Gorton Mount Road

Proposed Elevations (E. and N.) (Amendments Identification)

GMR-KMA-XX-XX-DR-A-7103

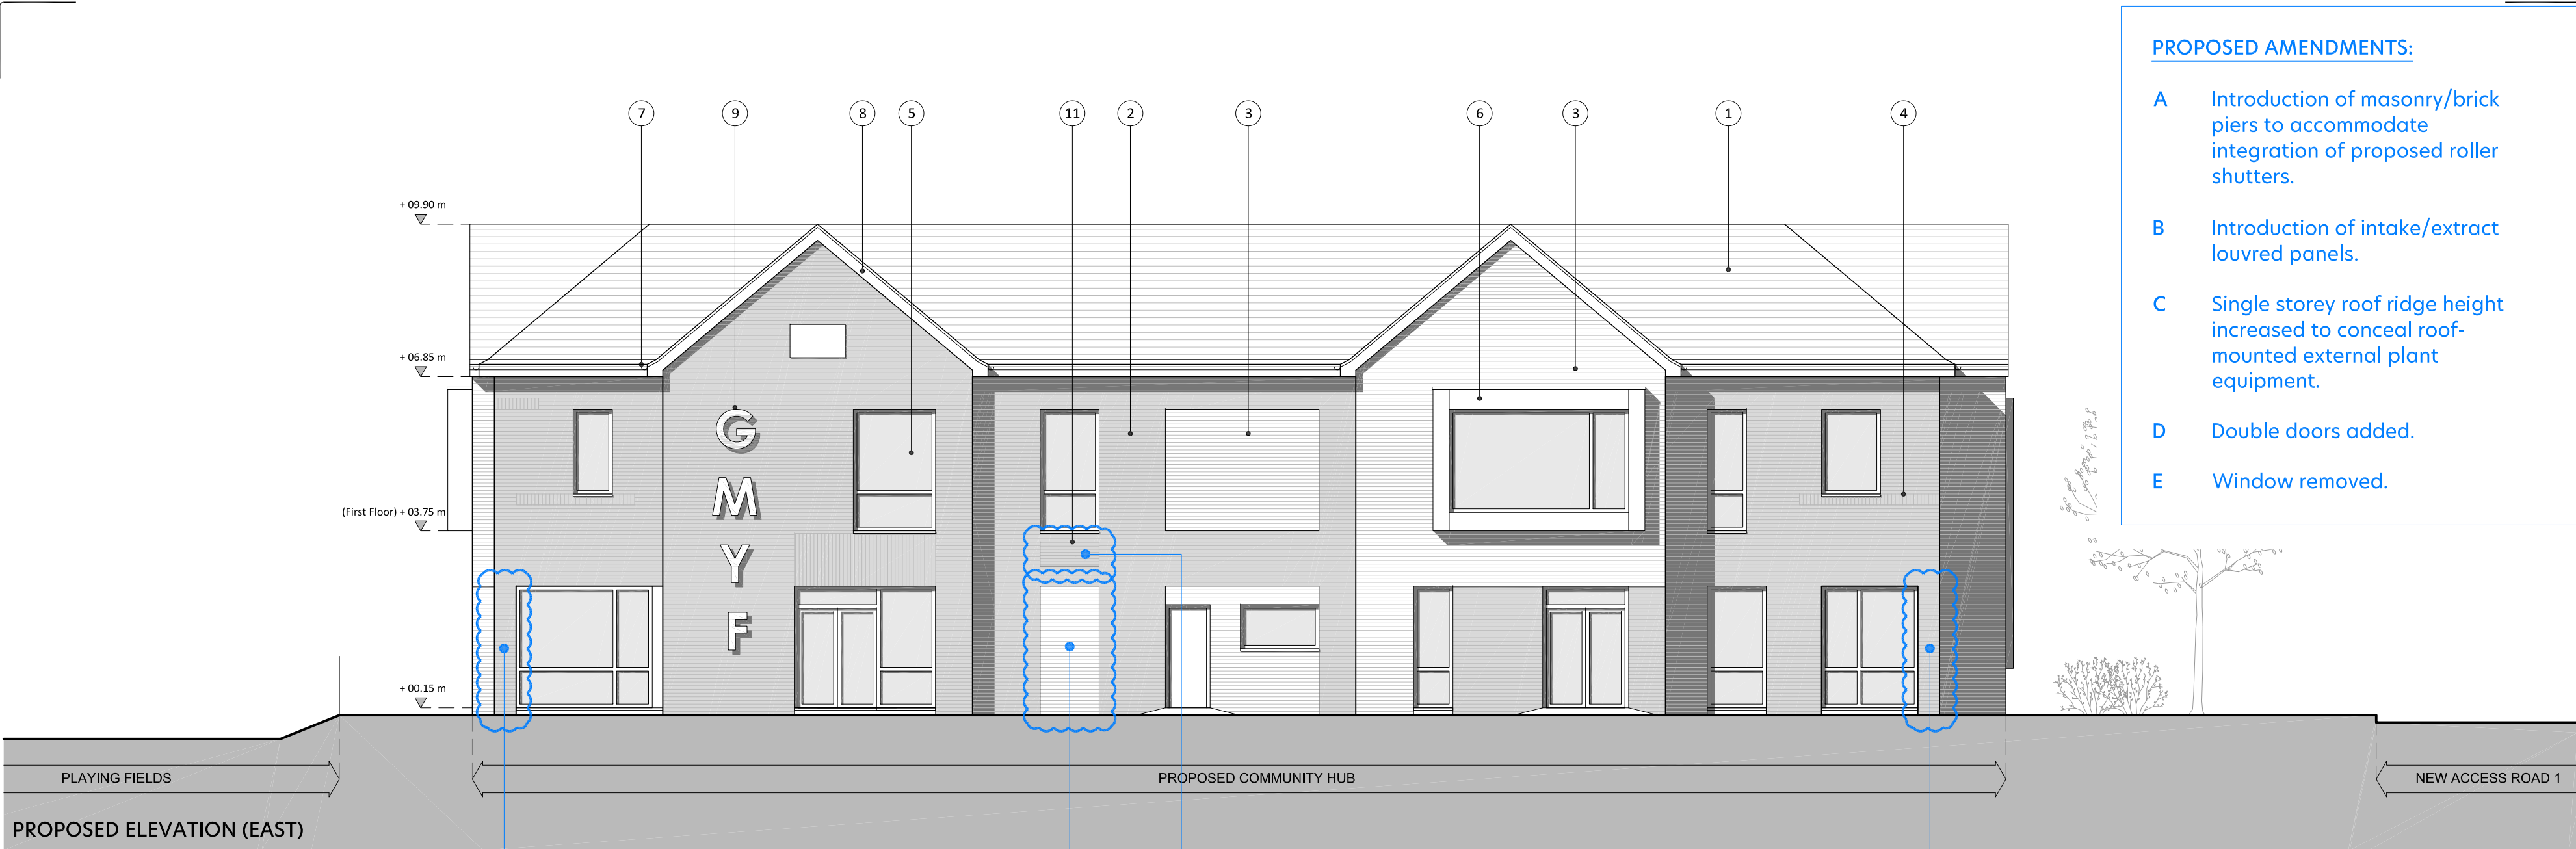
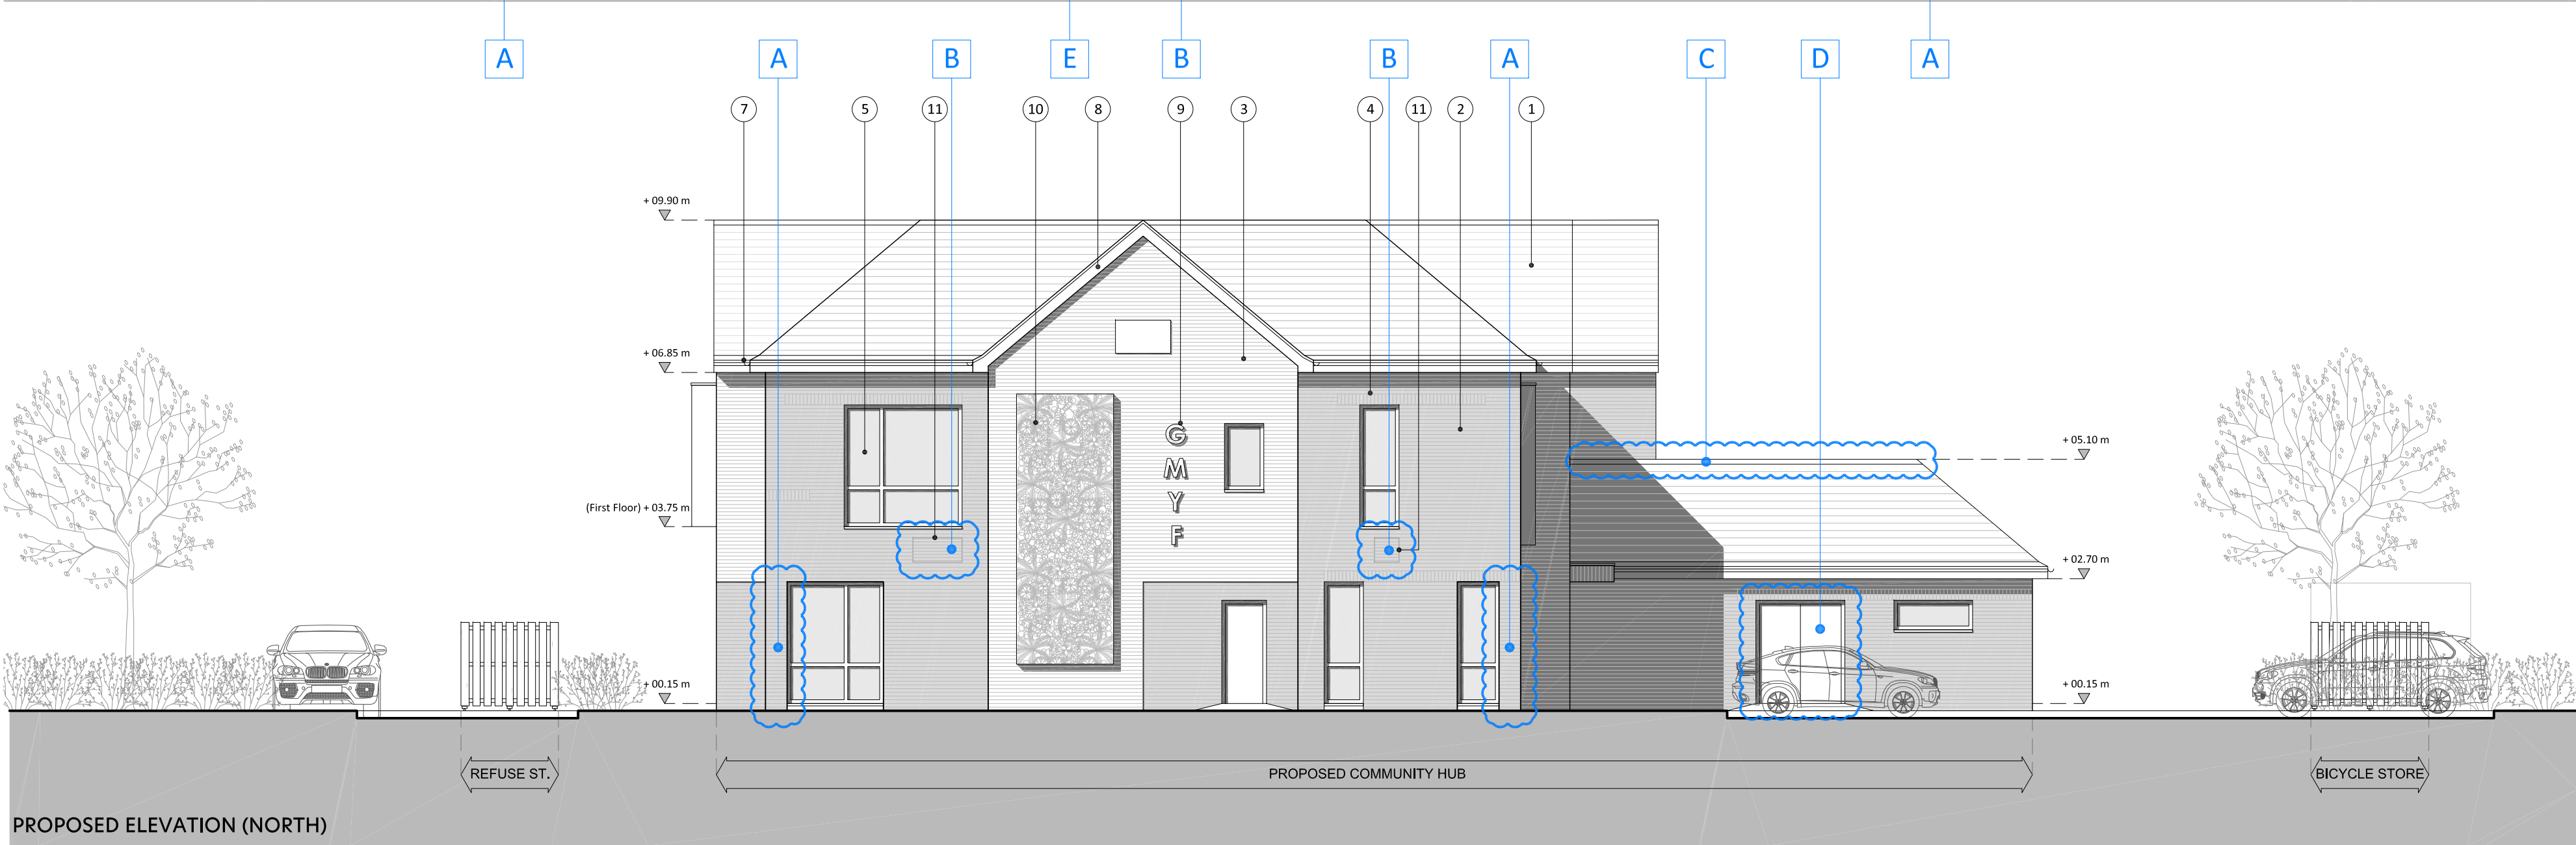
- A** Introduction of masonry/brick piers to accommodate integration of proposed roller shutters.
- B** Introduction of intake/extract louvred panels.
- C** Single storey roof ridge height increased to conceal roof-mounted external plant equipment.
- D** Double doors added.
- E** Window removed.
